Technical Bulletin

Bulletin No.: PRO-03-30

Subject: E-1 Single Circuit Brake Valve Obsolescence And Changeover

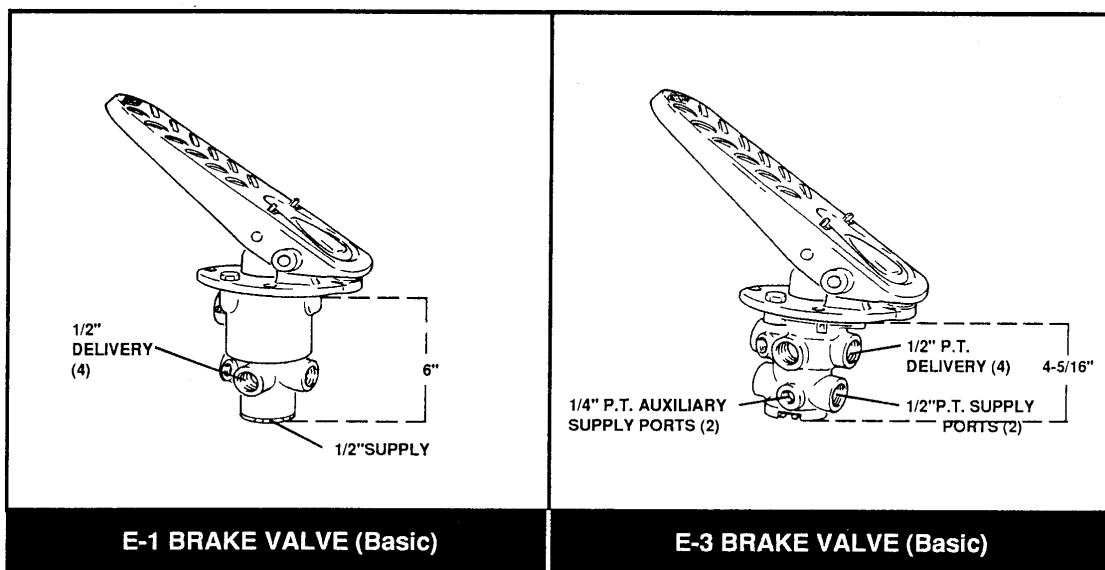
This changeover is the most easily accomplished since the existing vehicle air lines, along with the treadle and mounting plate may be reused. The E-3, like the E-1, is a single circuit brake valve. It is substantially shorter than the E-1 and is no larger in diameter and therefore should present little or no physical fit problems. The E-3 is equipped with four ½" PT delivery ports and two ½" PT and two ¼" PT supply ports. The E-1 is equipped with a single ½" PT supply and four ½" PT delivery ports. Refer to Figures 1 & 3. Reference catalog pages 03-C-2 & 3 for the E-1 and 03-E-1 to 4 for the E-3.

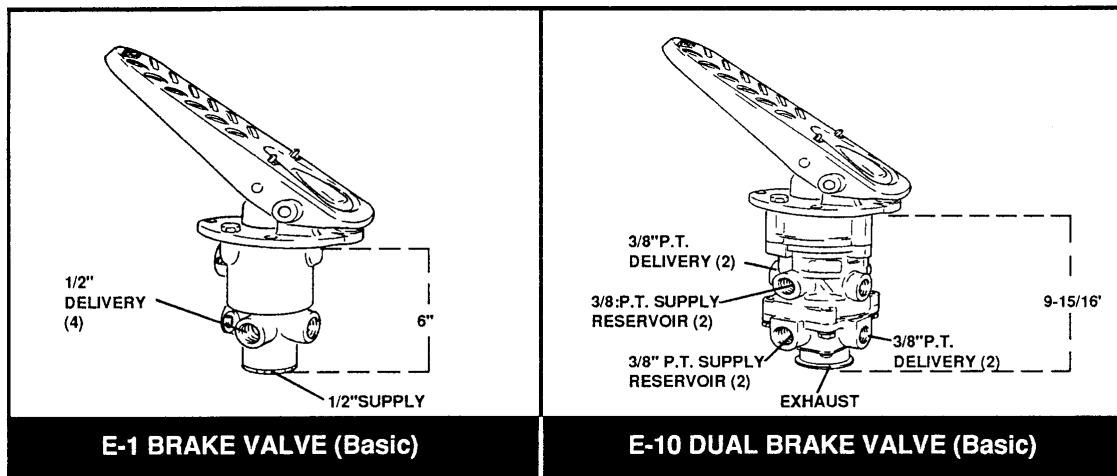
The E-10 dual circuit brake valve may be used to replace single circuit E-1 without converting the entire coach to a dual brake system. The E-10 is the current standard on many coaches today and more closely approximates the brake "feel" provided by the E-1. The existing treadle and mounting plate can be reused on the E-10. Refer to Figures 2 & 3. Reference catalog pages 03-C-2 & 3 for the E-1 and 03-J-1 & 2 for the E-10.

Since the E-10 is a dual brake valve some piping changes will be required. The single air supply line which was connected to the E-1 must be branched into two lines and connected to the separate primary and secondary supply ports of the E-10. In addition, the delivery line leading to the coach rear axle brakes **MUST BE CONNECTED TO THE PRIMARY DELIVERY PORT OF THE E-10**. The delivery line leading to the coach front brakes should be connected to the secondary delivery ports on the E-10. The air delivery connections specified are required due to the inherent 4 psi differential in delivery pressure between the primary and secondary circuits of a dual brake valve. The E-10 is approximately 2 inches longer than the E-1, and is no larger in diameter. There must be adequate clearance below the existing E-1 in order to install the E-10. The E-10 is equipped with four 3/8" PT delivery ports and four 3/8" PT supply ports (two supply and delivery ports for each circuit). The E-1 is equipped with a single 1/2" PT supply and four 1/2" PT delivery ports.
